Item ID: D206-667-201TRN Accept ***N900040100*** Setup Start ***NS1***
 Revision ID: Stop ***NS2***
 Item Name: Crosstube Turning Detail
 Start Date: 4/16/14 Start Qty: 1.00 ***1*** Cust Item ID:
 Required Date: 5/01/14 Req'd Qty: 1.00 ***1*** Customer:
 Reference:

DART AEROSPACE LTD		Work Order:	116475
Description: Crosstube Assembly		Part Number:	D206-667-241
Inspection Dwg: D206-667-241 Rev: C		Page 1 of 2

DRAWING NO. D206-667-241	TITLE CROSSTUBE ASS'Y (206B HIGH AFT)	REV. C	DART AEROSPACE LTD ENGINEERING ORDER		D.E.O. NO. D206-667-241-C-1	SHEET NO. SHEET 1 OF 1	SCALE NTS
DRAWN <i>q</i>	CHECKED <i>AS</i>	MFG. APPR. <i>AM</i>	APPROVED <i>WD</i>		DE APPR. <i>HA</i>		
DATE 11.07.15	DATE 11.08.22	DATE 11.08.22	DATE 11/08/22		DATE 11.08.22

REPLACE MAGNOBOND WITH PROSEAL.

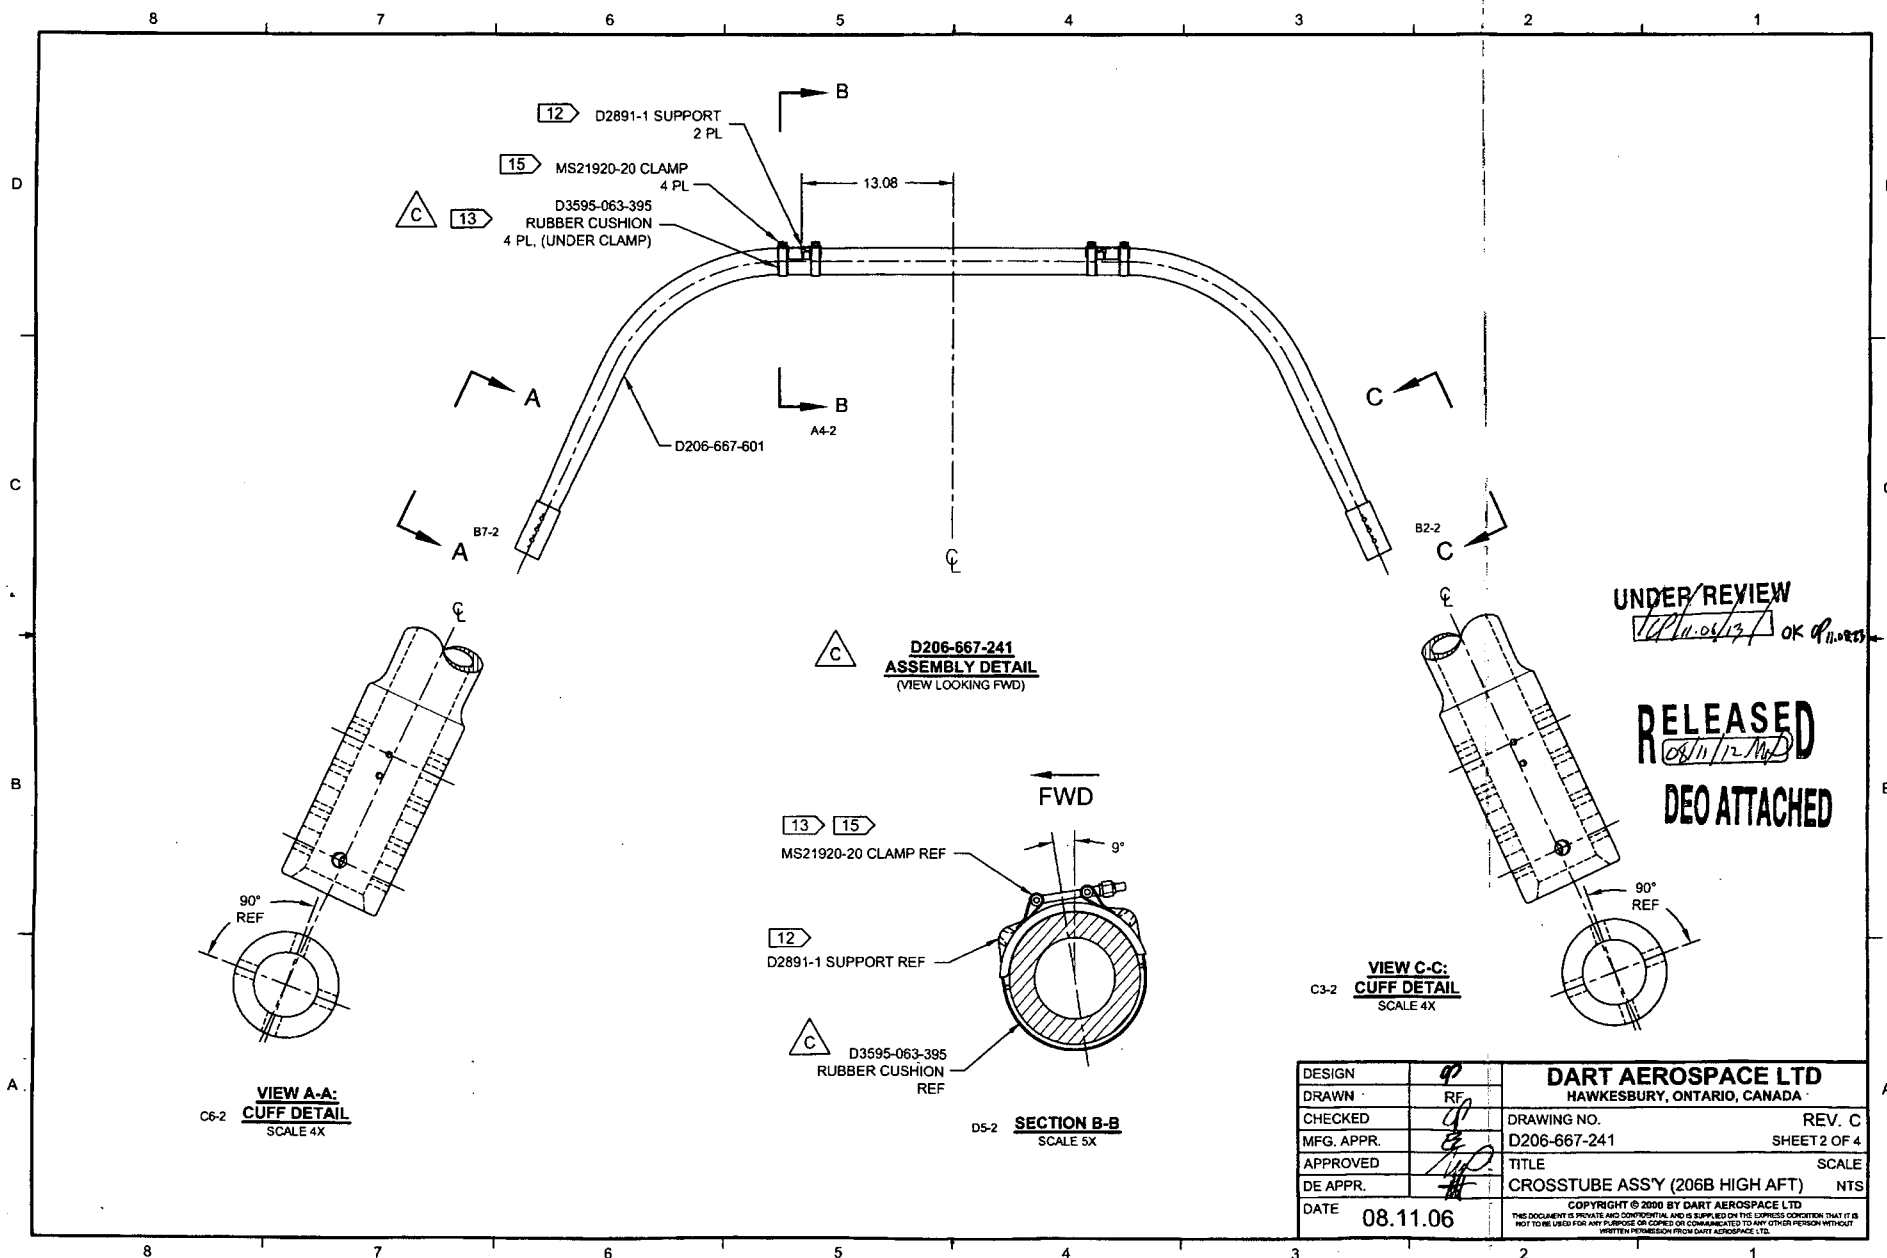
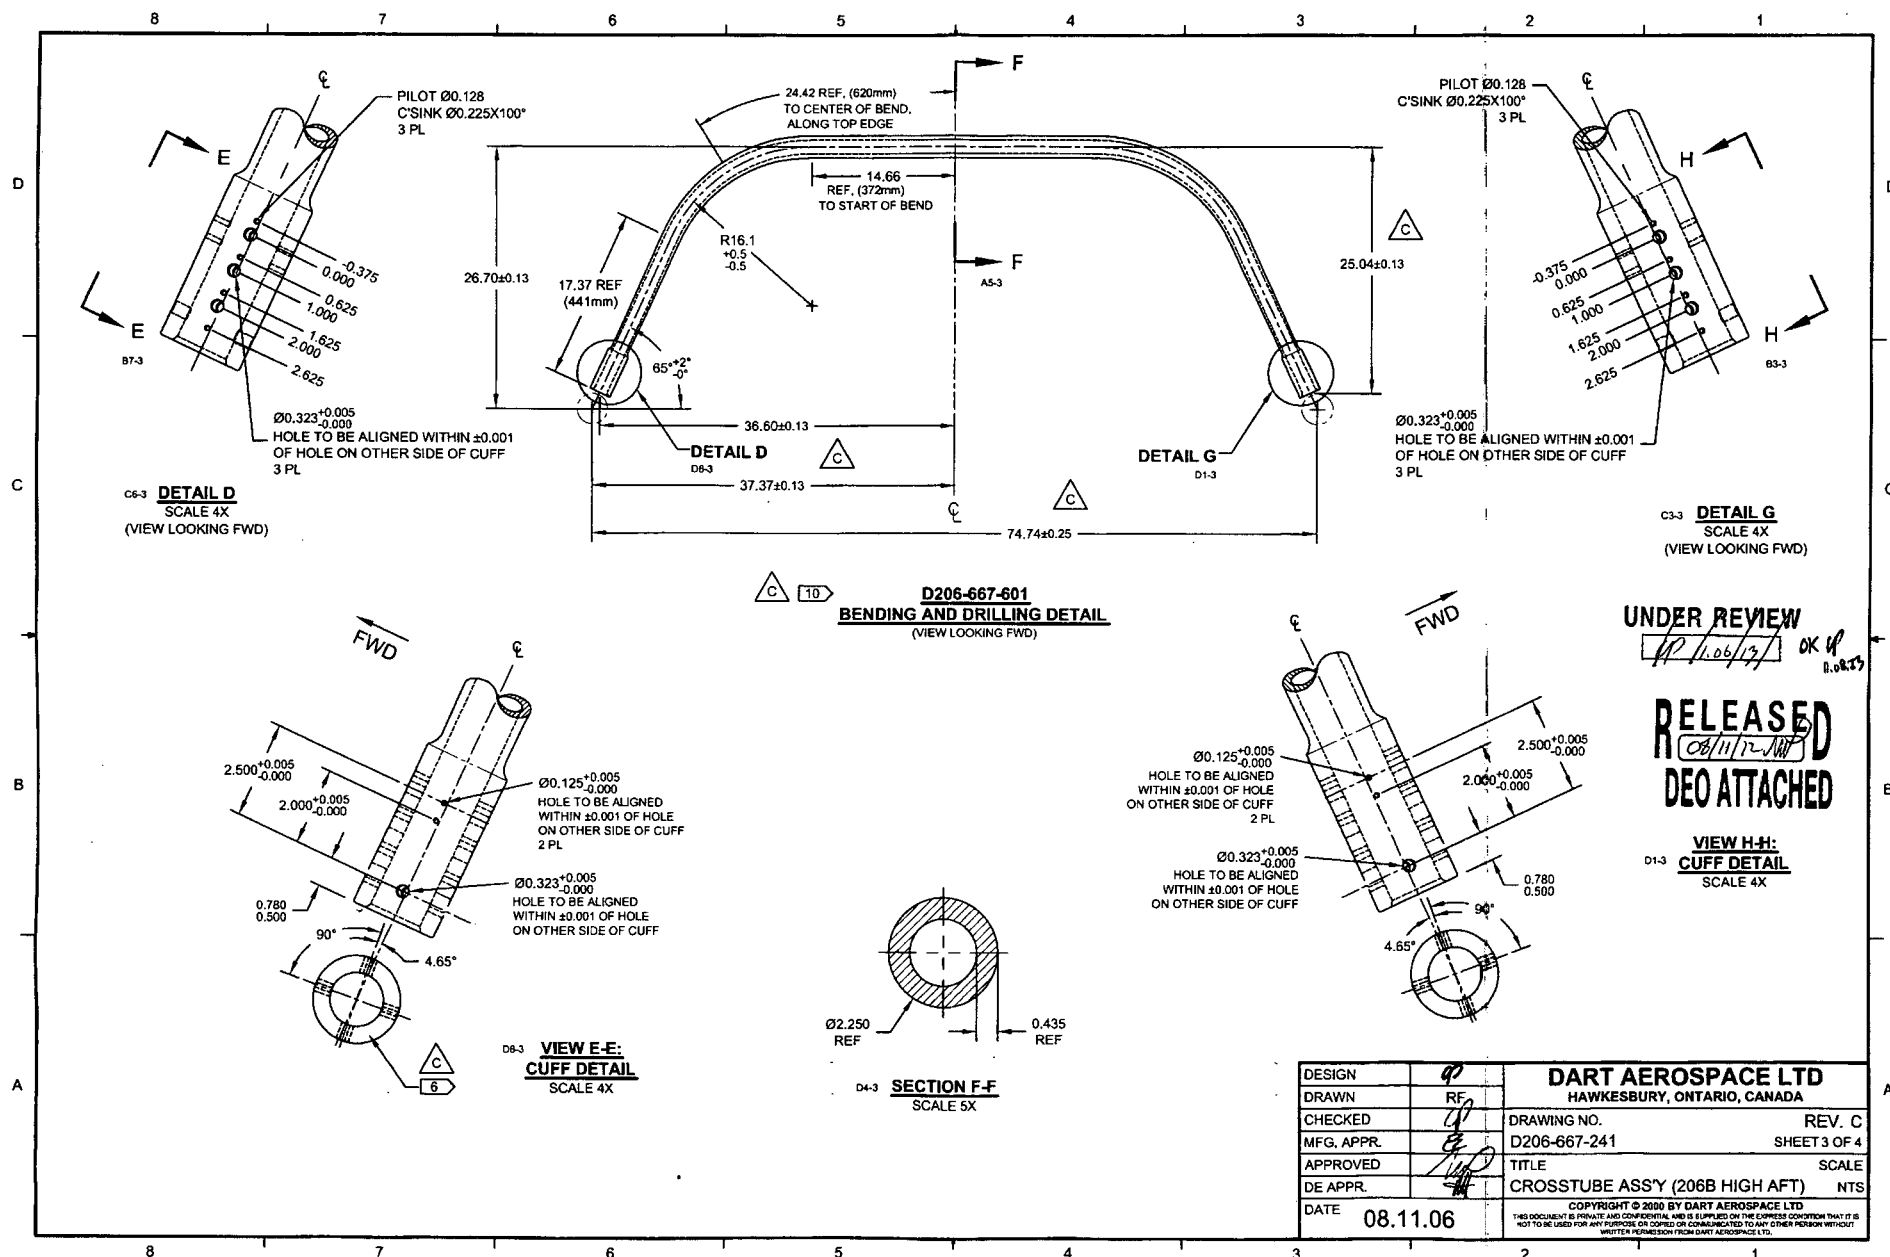
NOTE 12 & 15, SHEET 1 IS AMENDED AS FOLLOWS:

Item	Qty -241	Part Number	Description
6	A/R	PROSEAL 890 B-2	SEALANT, AMS-S-8802 CLASS B-2

- 12) TO INSTALL D2891-1 SUPPORT: ABRASE MATING SURFACE OF SUPPORT AND CROSSTUBE WITH 180-GRIT SANDPAPER AND REMOVE RESIDUE WITH MEK (OR EQUIVALENT). APPLY A 0.04" TO 0.07" THICK LAYER OF PROSEAL 890 CLASS B-2 (OR AMS-S-8802 CLASS B-2) SEALANT TO MATING SURFACE OF SUPPORT.
- 15) TORQUE CLAMPS 80 TO 100 IN-LB. ENSURE AT LEAST 1.5 THREADS SHOWING IN SAFETY AND THAT NUT HAS NOT BOTTOMED-OUT AFTER TORQUING. **PRIOR TO PACKAGING, RE-CHECK TORQUE ON CLAMPS AFTER PROSEAL 890 SEALANT HAS CURED FOR 72 HOURS.**
